M-9A0 (Calpella + N11P/M Discrete Graphic)

FOXCONN		HON HAI Precision Ind. Co., Ltd.	
Title		ARD(Power)	
Size	Document Number	Rev	
Custom	M9A0 MP	1.1	
Date:	Wednesday, October 28, 2009	Sheet	5 of 73

FOXCONN		HON HAI Precision Ind. Co., Ltd.	
		CCPBG - R&D Division	
Title	PCH (PCI-E, SMBUS, CLK)		
Size	Document Number	Rev	
Custom	M9A0 MP	1.1	
Date:	Friday, October 23, 2009	Sheet	10 of 73

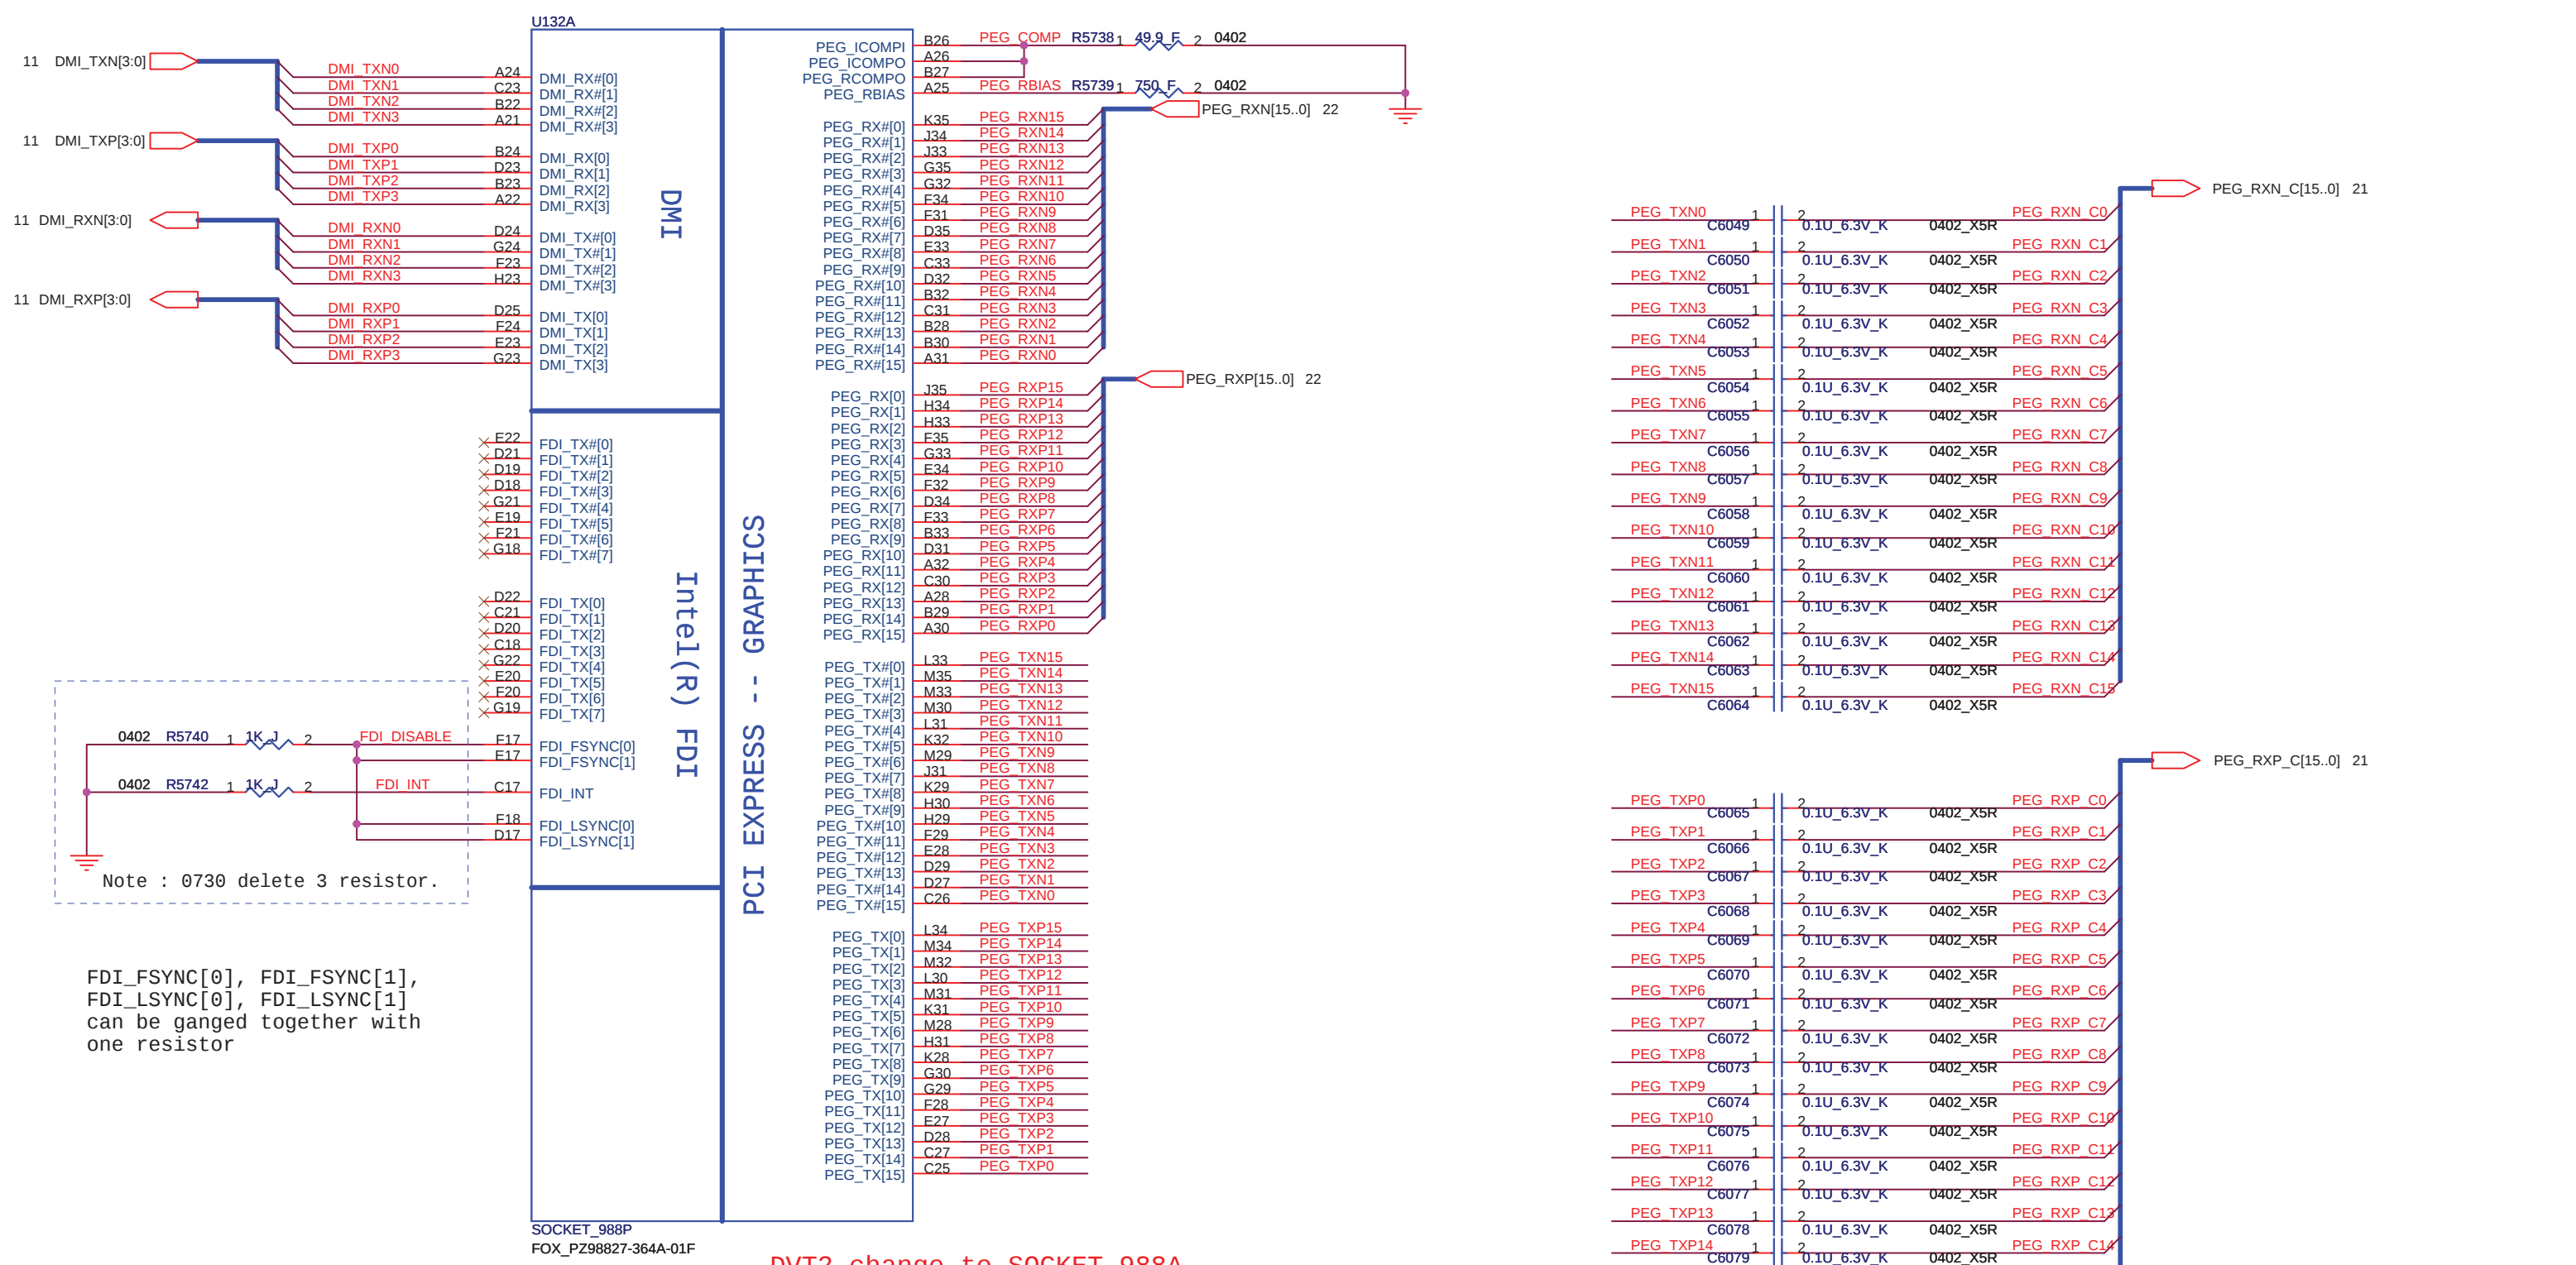
DVT2 change to SOCKET_988A

```
2009.10.19
Change RP81 TO NC
Change RP82 TO mount
```

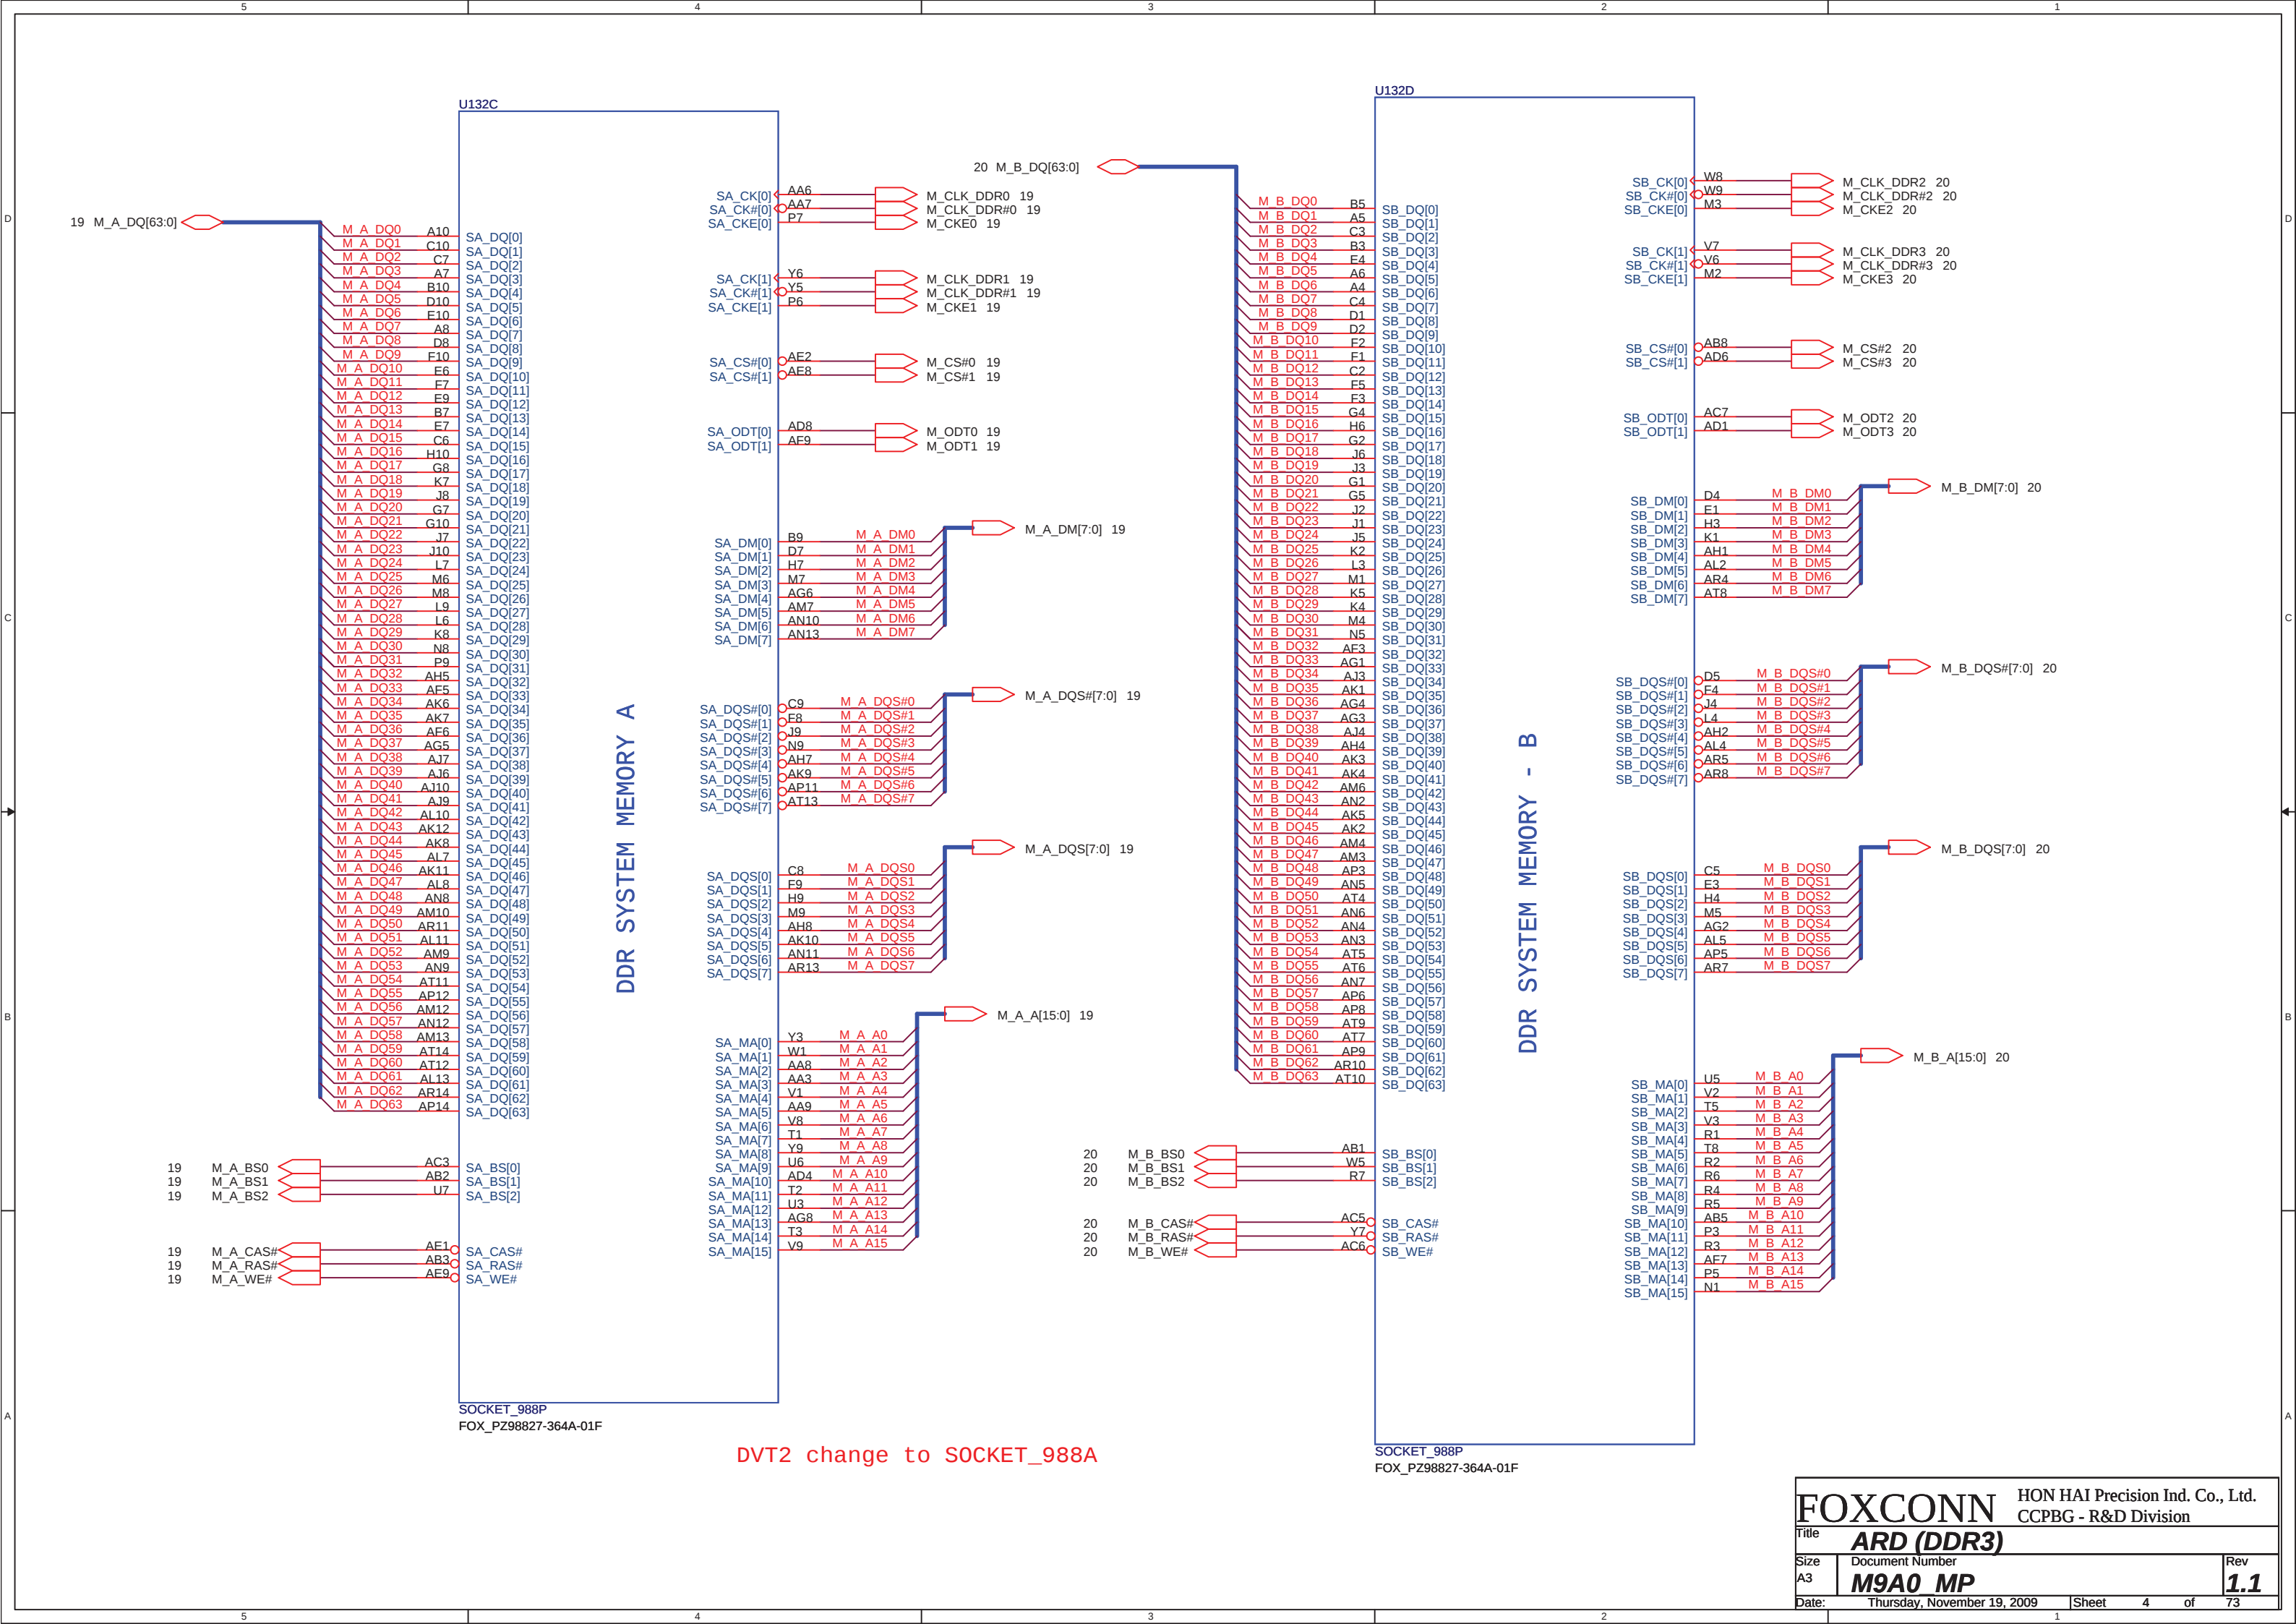
2009/09/10
Change C6131 from NC to 0.047U for DVT2

DVT2 change to SOCKET_988A

2009/09/12
Delete R5785 0ohm resistor for voltage drop problem

2009.10.23
Delete R5786 for PVT

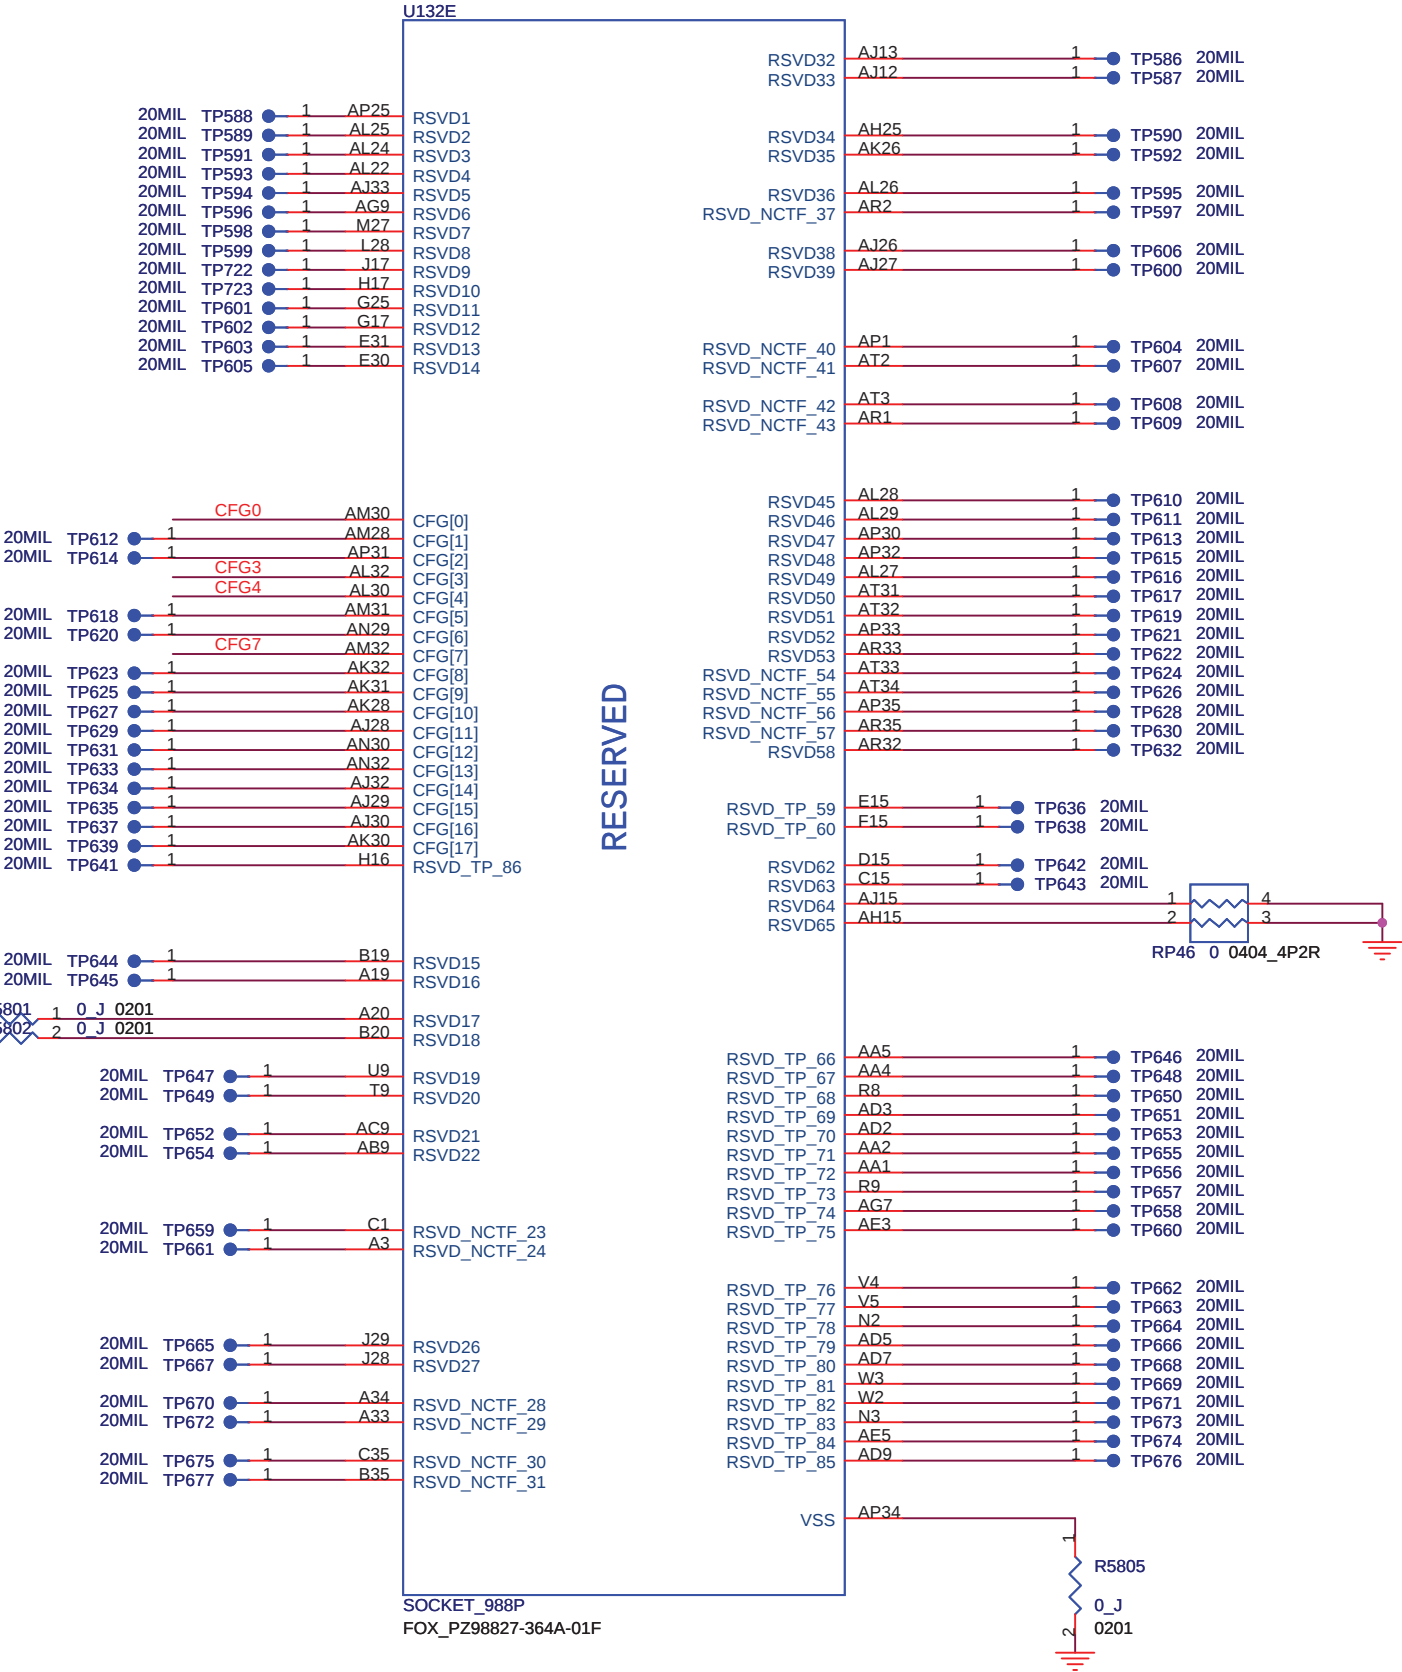
Intel has determined that the workaround (3.01K pull down to Vss on signal CFG[7]) is not robust. Intel recommends not implementing this workaround at this time (CFG[7] should not be pulled down).
Intel recommends not to test for PCI-E Express 2.0 Jitter specification compliance for the affected steppings.
